**WELCOME**  
To a Regular Meeting of the  
**Coeur d'Alene City Council**  
Held in the Library Community Room at **6:00 P.M.**  
**AGENDA**

**June 4, 2024**

1. (Quasi-judicial) Appeal Hearing for an appeal made by Joan Woodard of DR-1-24AA; CDA Hotel, LLC (Mariott Hotel) located at 602 & 612 E. Sherman Avenue.

### Ground Floor Windows

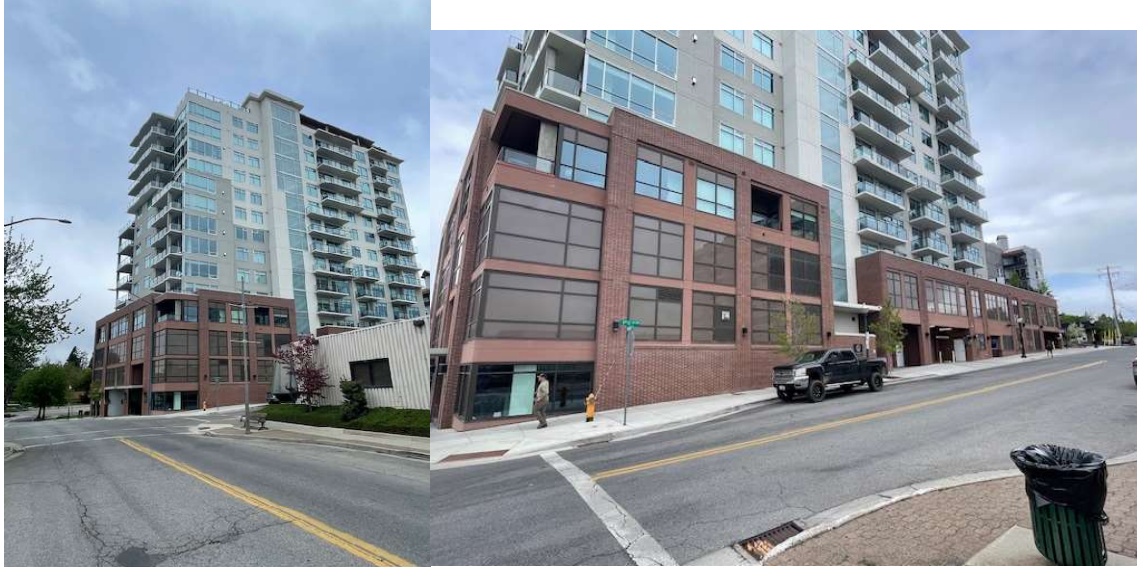
*This standard is partially met.*

The Sherman Avenue elevation meets the 40% transparency standard for vehicle-oriented streets with 45% window area.

The 6<sup>th</sup> Street elevation only has 26% transparency. 60% is required for pedestrian oriented streets.

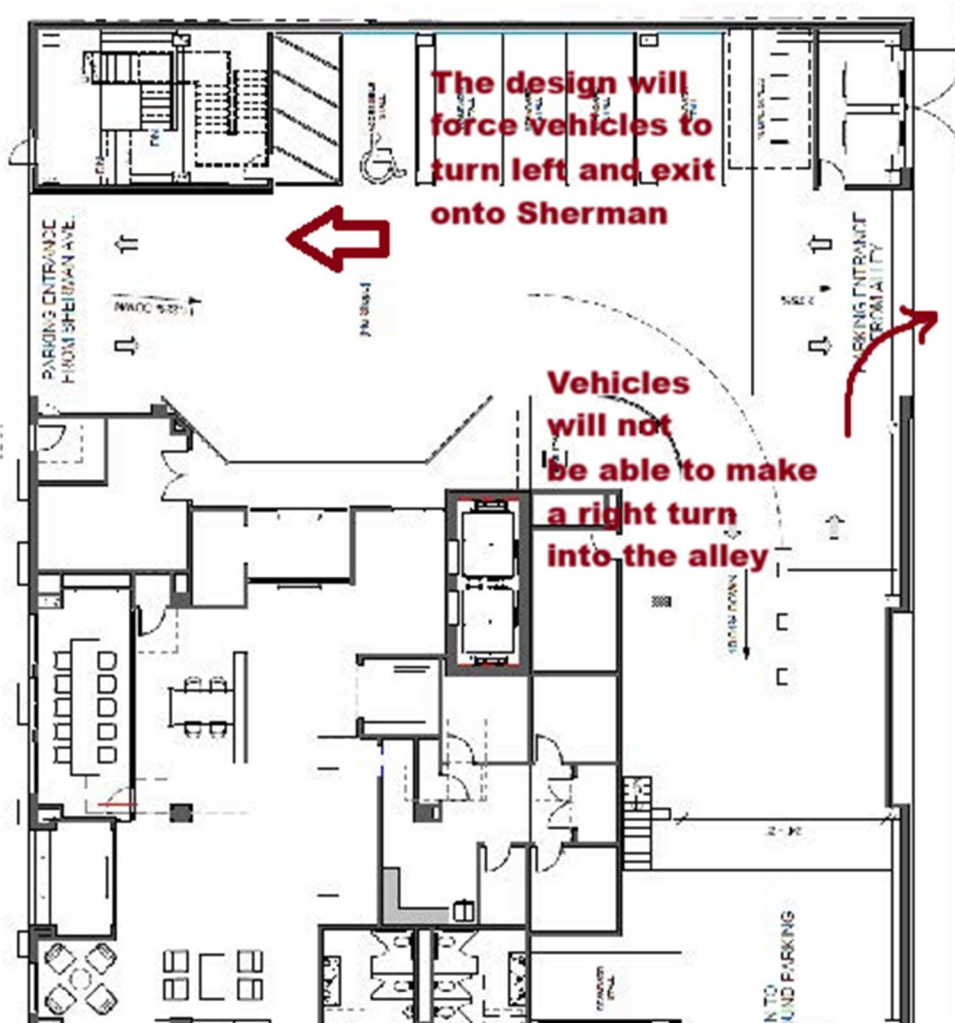
The site is over developed given the restrictions on Sherman Avenue and 6<sup>th</sup> Street. Sherman Avenue is a Vehicular-Oriented Street. Driveways are not prohibited but should be discouraged. 6<sup>th</sup> Street is a Pedestrian-oriented Street. No curb cuts are allowed on pedestrian oriented streets per the Guidelines, but many exceptions have been made over the last 20 years. This leaves the alley as the primary access. The alley as access would work for a residential development but would be insufficient for a hotel.

A driveway onto Sherman will cause congestion and interrupt the smooth flow of traffic with turning vehicles which will be discussed in detail below. A driveway onto 6<sup>th</sup> Street would be better and of far less impact to the area traffic flow. The City should provide a waiver of the 6<sup>th</sup> Street curb cut prohibition.

The Institute of Transportation Engineers, Trip Generation Handbook has a trip generation rate for hotels of 8.17 trips per room and a pm peak hour rate of .6 trips per room. The proposed 131 room hotel will generate 1070 trips per day and 79 trips during the pm (5:00 pm) peak hour. The projected traffic will reduce the level of service of the area roadways.

An unsignalized intersection analysis and queuing analysis is needed of the driveway on Sherman to understand the impact and congestion likely to occur. Vehicles turning left into the hotel are likely to block the 7<sup>th</sup> Street left turn pocket.
